**SUBJECT: Transmittal of Westinghouse Responses to Open Items Identified in the AP1000 Draft Safety Evaluation Report**

**Westinghouse Non-Proprietary Responses to  
AP1000 Draft Safety Evaluation Report (DSER) Open Items**

# AP1000 DESIGN CERTIFICATION REVIEW

## Draft Safety Evaluation Report Open Item Response

Figure 7.2-1 (Sheet 16 of 20)

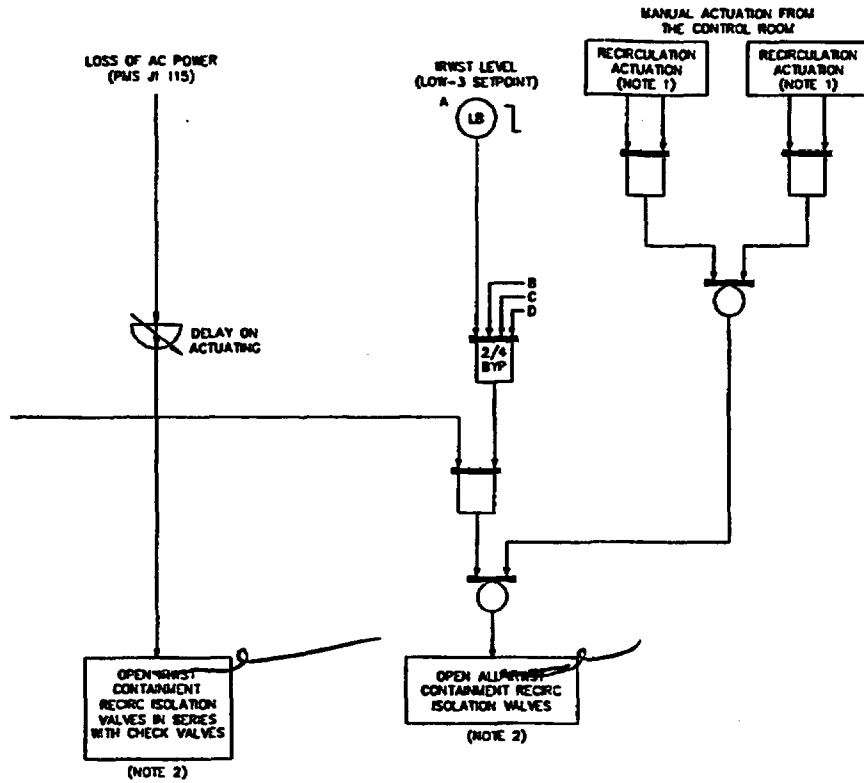
The functional logic relating to activation of the ~~in-containment refueling water storage tank~~ containment recirculation isolation valves is illustrated in Figure 7.2-1, sheets 15 and 16.

**Figure 1. Illustration of the SMA Event Tree HCLPF Property**

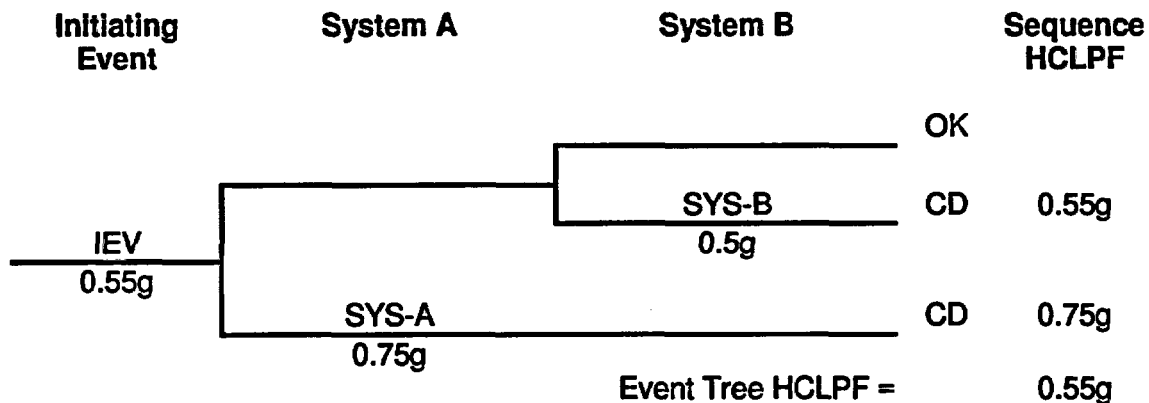
1. Every seismic CDF cutset contains an initiating event term. Thus, the HCLPF value for a cutset can not be lower than that of the initiating event HCLPF.
2. This can be visually seen as follows. Refer to Figure 1. In this figure, one of the two mitigating systems that prevent core damage has a smaller HCLPF than that of the initiating event, the other has a larger HCLPF value. Then, the event tree HCLPF value is equal to the initiating event HCLPF value.

This property enables us to calculate the plant HCLPF directly from the lowest of the initiating event HCLPFs as 0.5g, as explained in Section 55.4.2. Thus, the plant Boolean expressions are not further developed. The general conclusions and insights obtained in AP600 for the seismic margins evaluation hold for the AP1000.
